HISTORIC AND DESIGN REVIEW COMMISSION

HDRC CASE NO: 2017-408
ADDRESS: 501 S MAIN AVE
503 S MAIN AVE
505 S MAIN AVE
507 S MAIN AVE
509 S MAIN AVE
400 S FLORES ST
LEGAL DESCRIPTION: NCB 927 BLK LOT N IRR 11.41 FT OF A 40 FT OF B3
NCB 927 BLK LOT B1,B2, N 10 FT OF B3 & E 64 FT OF N 150.42 OF A10
NCB 927 BLK LOT 12
ZONING: D, RIO-3
CITY COUNCIL DIST.: 1
APPLICANT: Dale Carse
OWNER: HEB Grocery Company
TYPE OF WORK: Construction of a surface parking lot
REQUEST:

The applicant is requesting a Certificate of Appropriateness for approval to construct a surface parking lot to be bound by E Cesar E Chavez Blvd to the south, S Flores to the west, Old Guilbeau to the north and Main to the east.

① OVERALL SITE PLAN
SCALE: 3/32" = 1'-0"

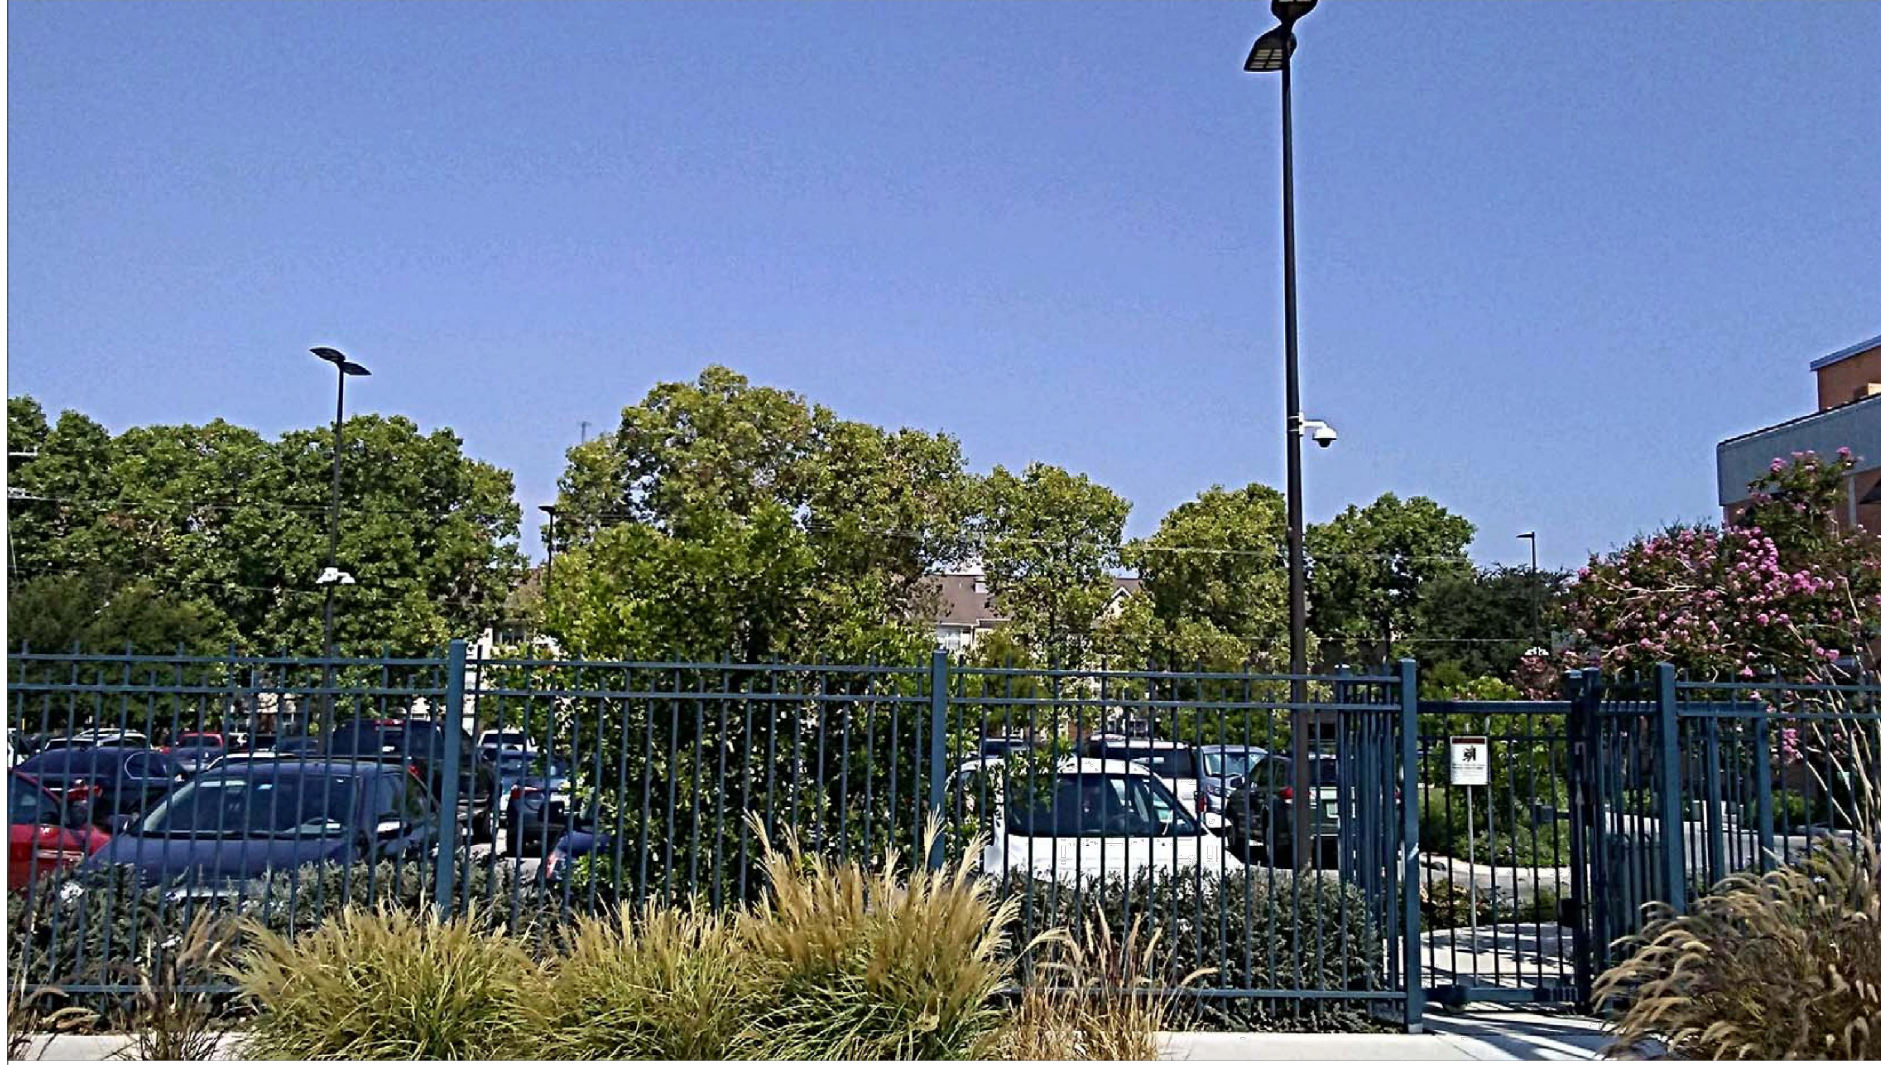
- b. PEDESTRIAN ACCESS – The UDC Section 35-672(a) notes that pedestrian access shall be provided among properties to integrate neighborhoods. The applicant has noted the installation of new sidewalks around the site to be six (6) feet in width. This is consistent with the UDC.

- c. PAVING MATERIALS – The UDC Section 35-672(a)(3) notes that paving materials for pedestrian pathways shall use visually and texturally different materials than those used for parking spaces and automobile traffic. The applicant has proposed concrete pathways and sidewalks. This is consistent with the UDC.

- d. AUTOMOBILE PARKING – The applicant has noted a primary use on the lots to be automobile parking. This is permitted in RIO-3 at this location due to its distance from the river right of way. Per the UDC Section 35-672(b)(2), there is no maximum percentage of lot line coverage by surface parking in RIO-3. The applicant's proposed parking location and site design is consistent with the UDC.

- e. CURB CUTS – The applicant has proposed one curb cut to facilitate automobile entry into the parking lot. This curb cut and corresponding entry is to be located on Old Guilbeau Street, at the interior of the site, removed from major automobile and pedestrian thoroughfares. Staff finds the proposed curb cut location to be appropriate and consistent with the Guidelines. The applicant has noted an overall curb cut width of 54' – 8". While the UDC notes that a width of twenty-five (25) should not be exceeded for curb cuts, staff finds that the location of the curb cut on the interior of the site will not negatively impact automobile or pedestrian traffic on nearby streets.

Staff recommends approval as submitted based on findings a through g with the following stipulation:

2 TYP. SECURITY FENCE ELEVATION
SCALE: 3/4"=1'-0"

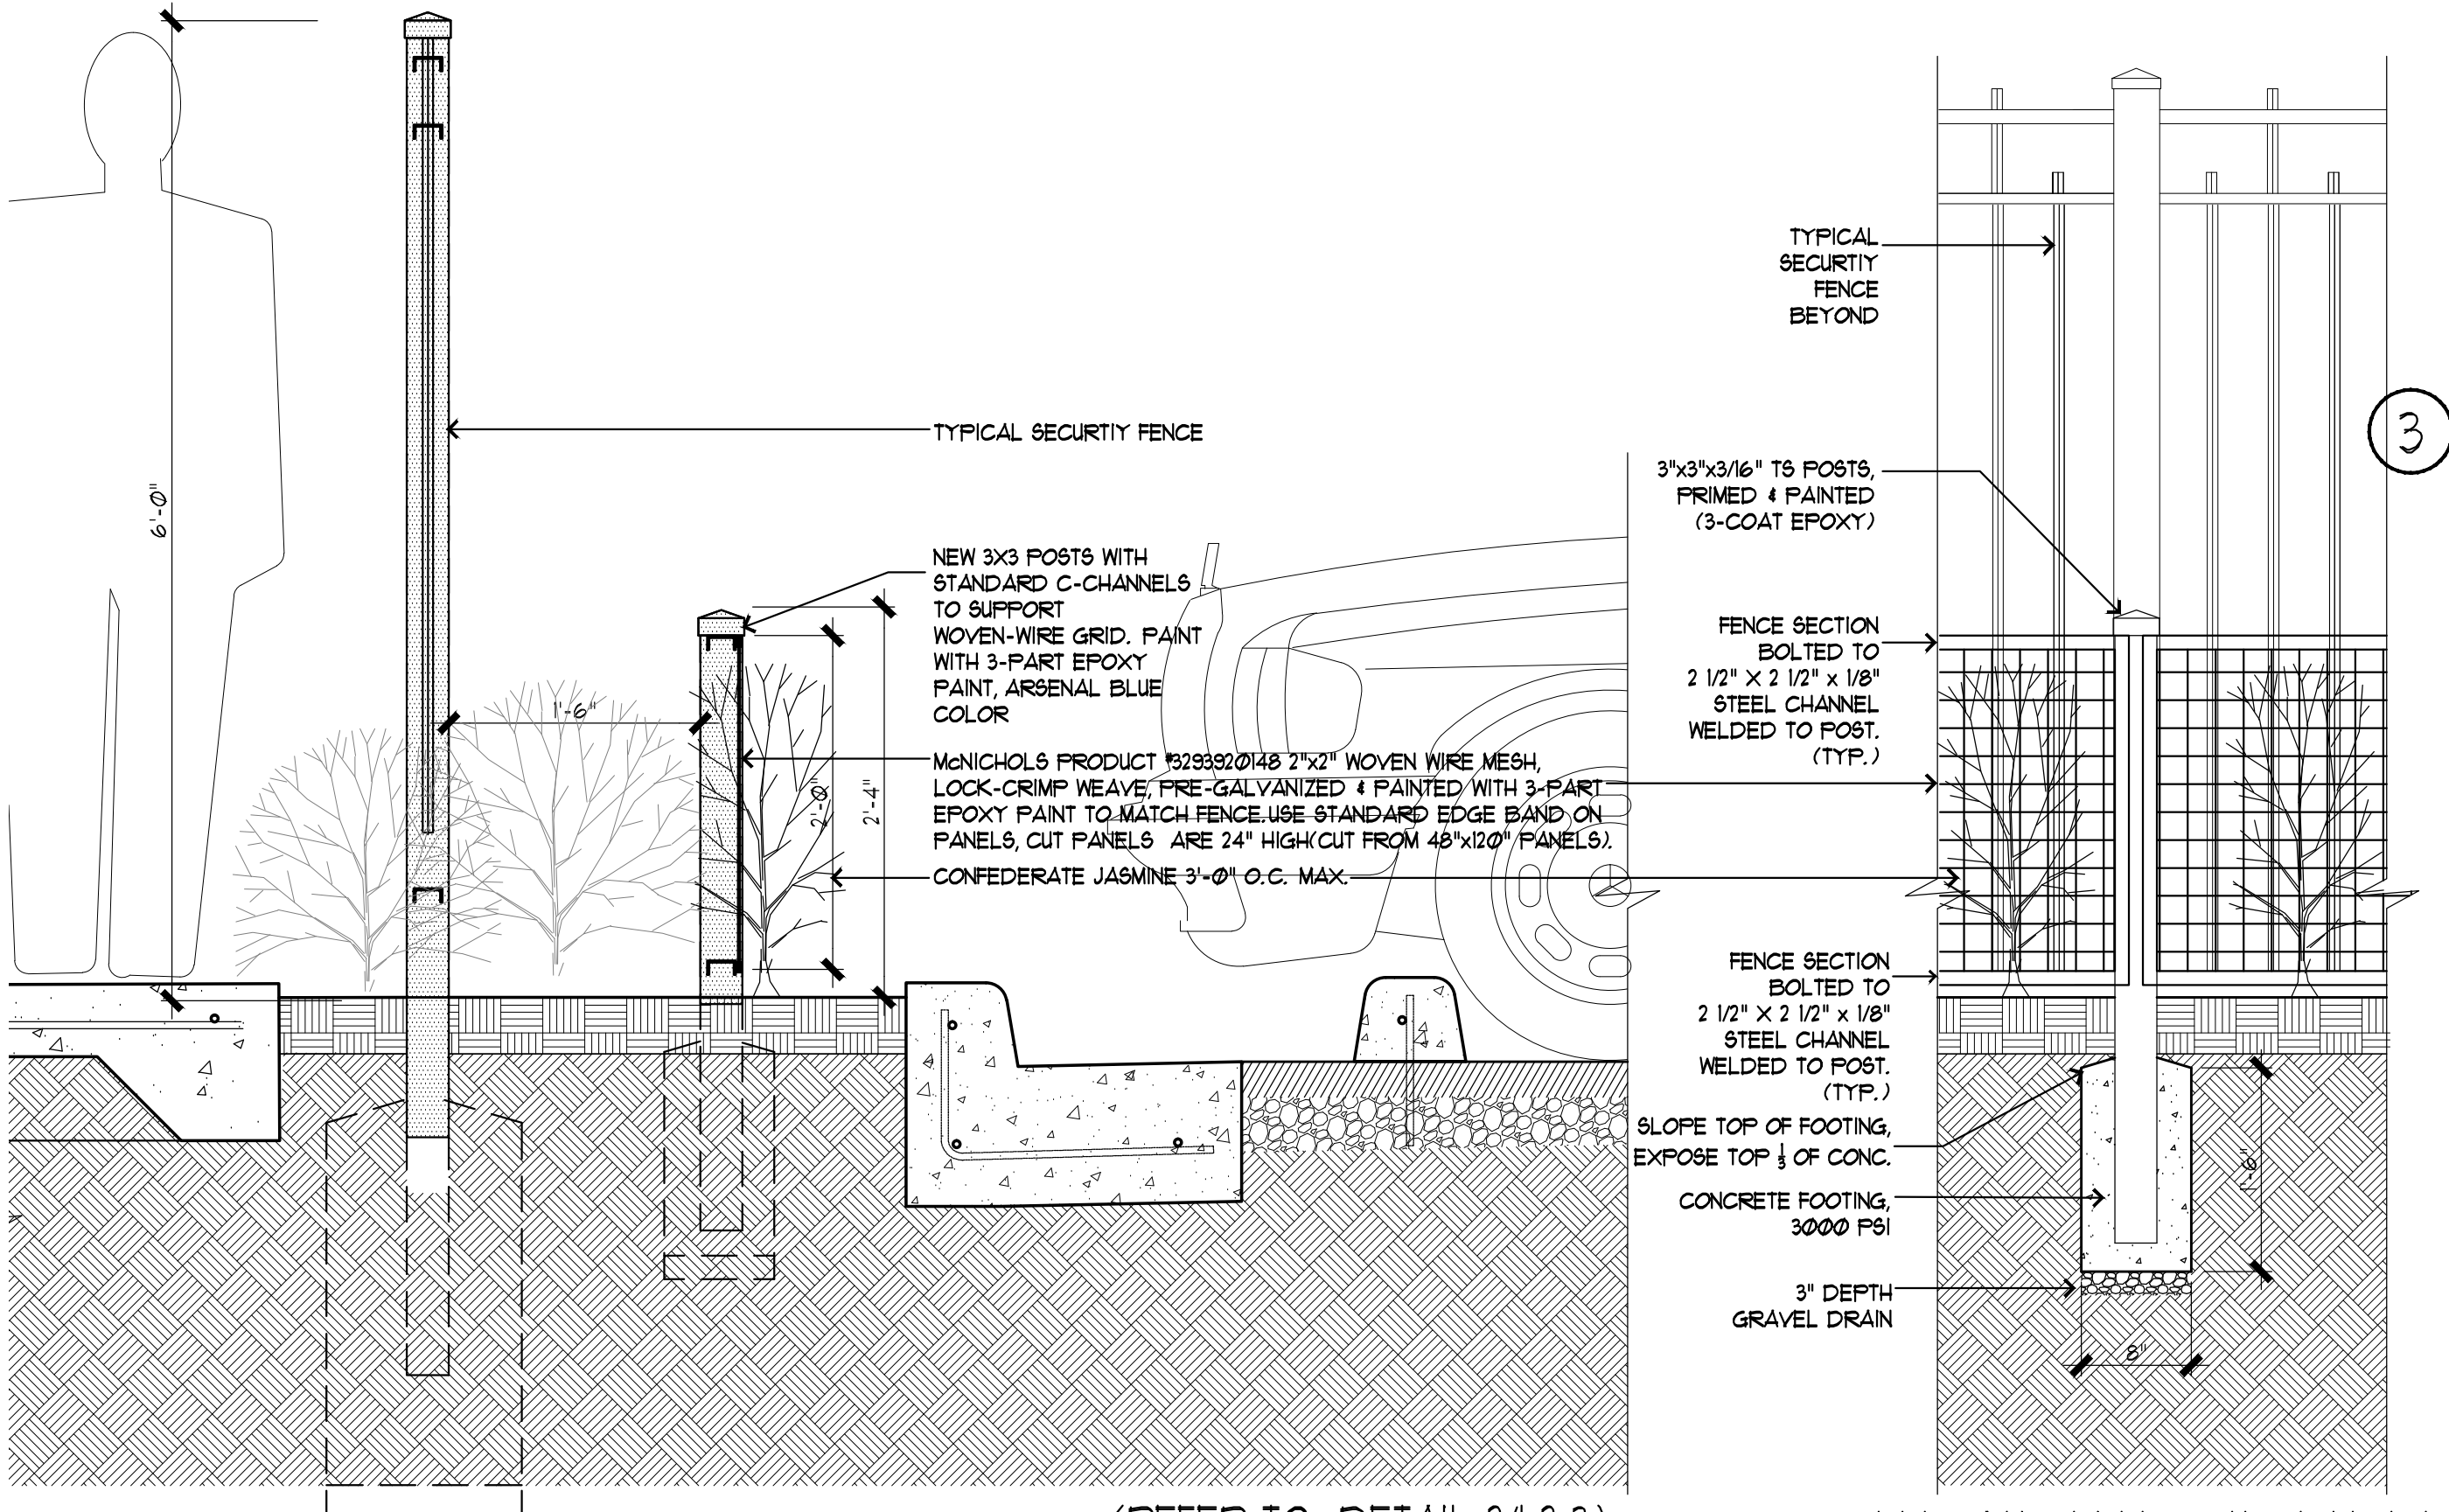
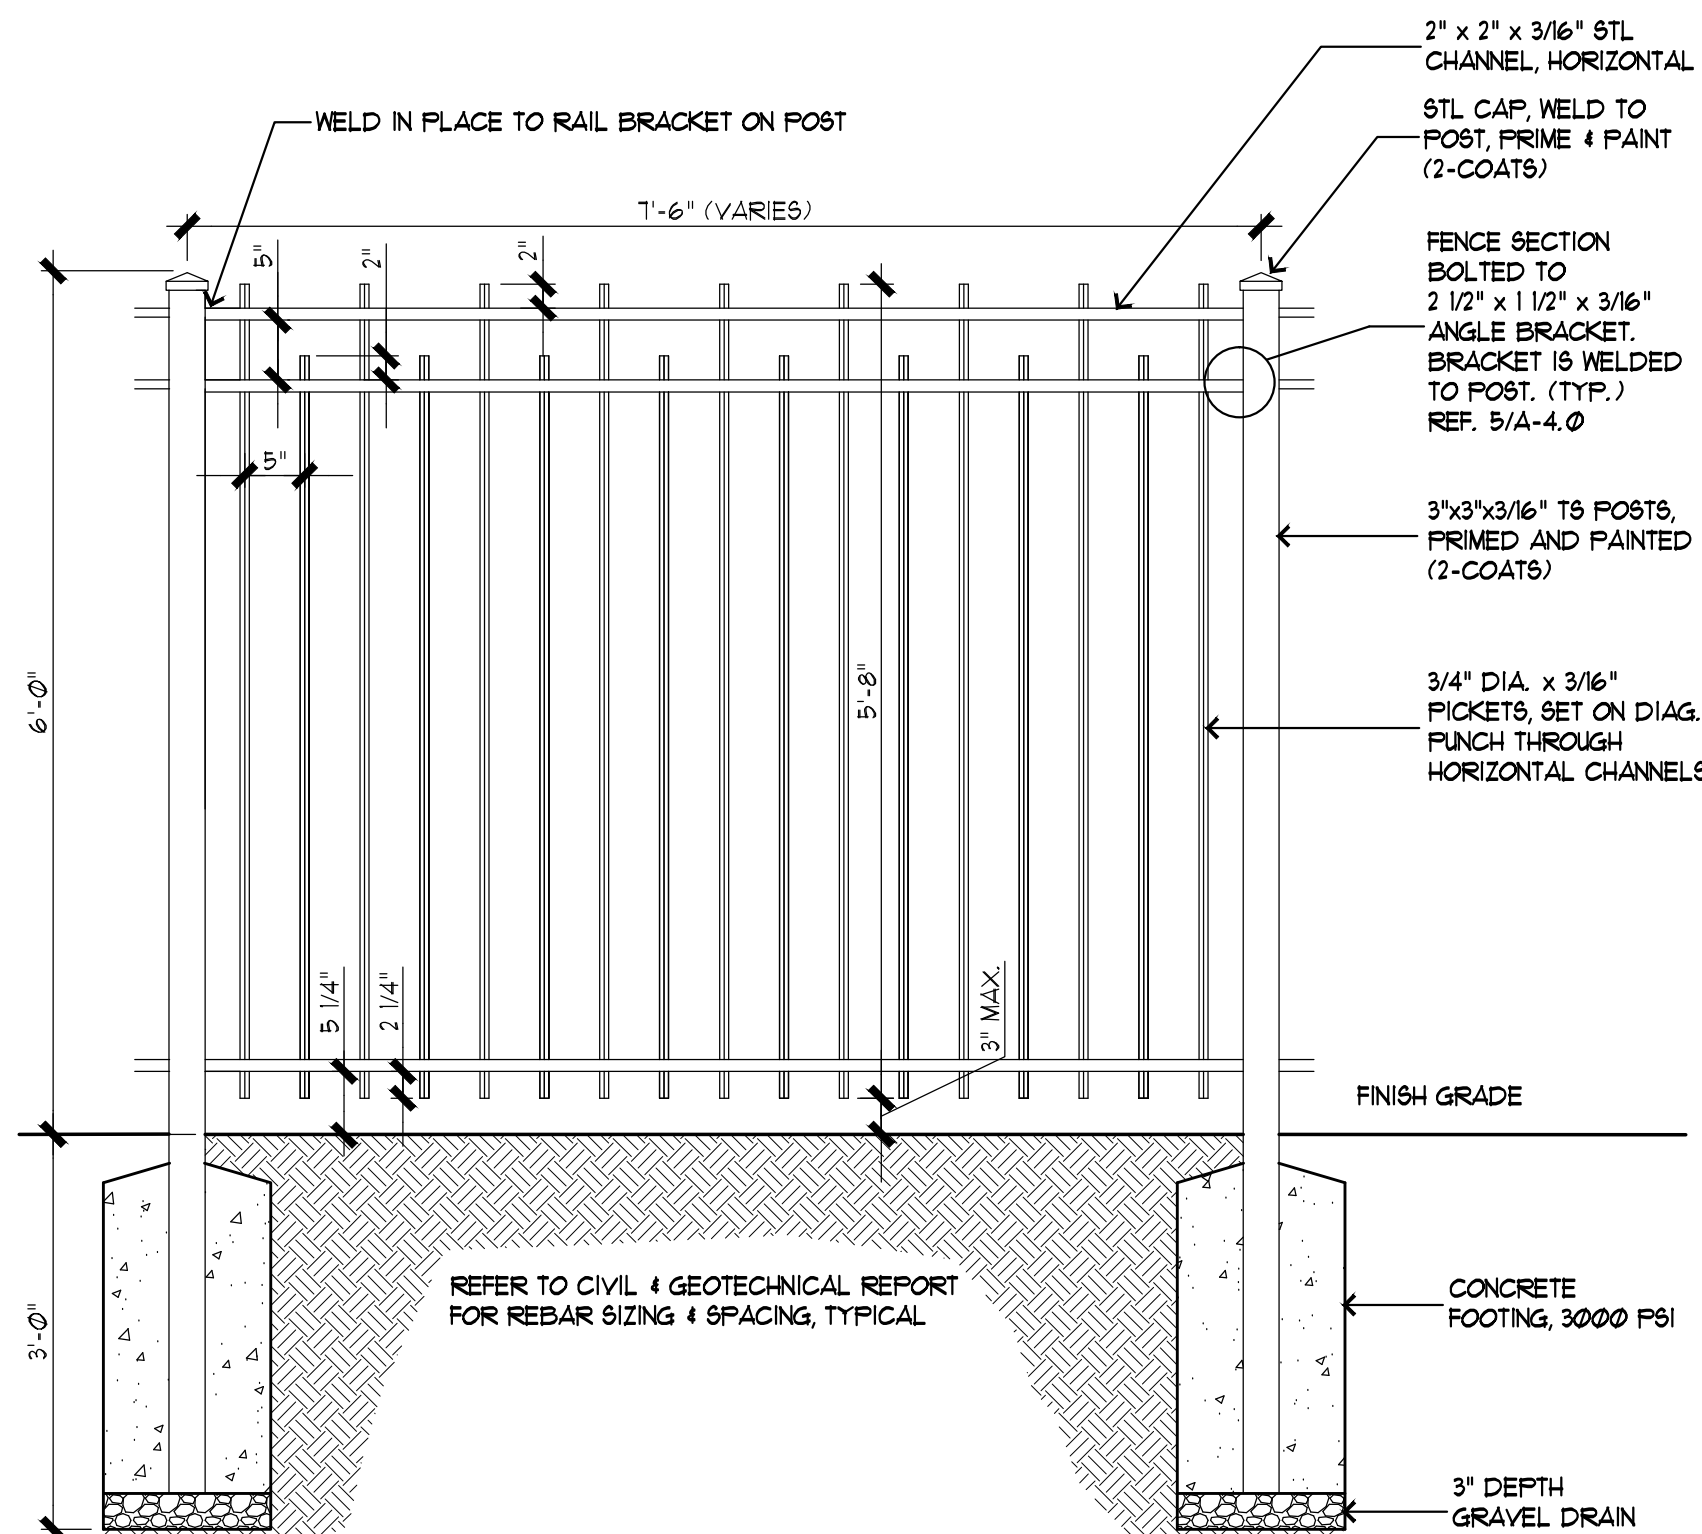
- f. PARKING BUFFERING – Per the UDC Section 35-672(b)(3), parking areas should be screened or buffered from view of public streets, the San Antonio River and adjacent residential uses. The applicant has noted the installation of planted parking screens, a steel picket fence that is to be six (6) feet in height and additional setbacks and landscaped buffered within the property line. Staff finds the proposed installation appropriate.

- g. LIGHTING – The applicant has proposed parking lot lighting in the form of light poles. The applicant has noted these at eight (8) locations. Additionally, the applicant has proposed locate security kiosks, utility boxes and security access infrastructure on the site. Each of these will be located within the screened area. Staff finds their installation to be appropriate.
